**HIROSE ELECTRIC EUROPE B.V.**  
Hogehilweg 8, 1101CC, Amsterdam, The Netherlands

**Packaging Change Notification**

■ Product List Business430-19008\_DF12 Series Packaging specification change

■Details of change\_DF12 Series Packaging specification change

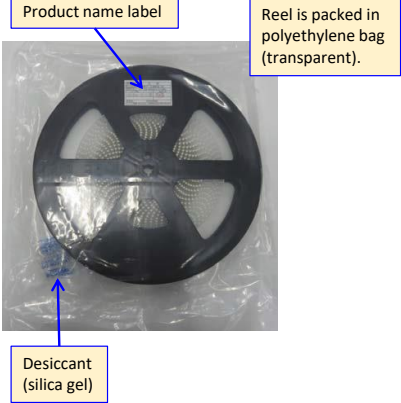
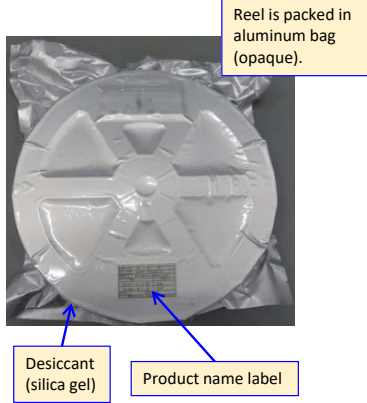
Before Change Polyethylene bag packing	After Change Aluminum bag deaeration packaging
 <p>Product name label</p> <p>Reel is packed in polyethylene bag (transparent).</p> <p>Desiccant (silica gel)</p>	 <p>Reel is packed in aluminum bag (opaque).</p> <p>Desiccant (silica gel)</p> <p>Product name label</p>
<p>Inside of Polyethylene bag packing</p>  <p>Product name label</p> <p>The reel is packed in a polyethylene bag with silica gel Only the product label is attached to the reel</p>	<p>Inside of Aluminum bag deaeration packaging</p>  <p>Product name label</p> <p>Humidity Indicator</p> <p>The reel is packed in an aluminum bag with silica gel and deaerated. Product label and humidity indicator are attached</p>
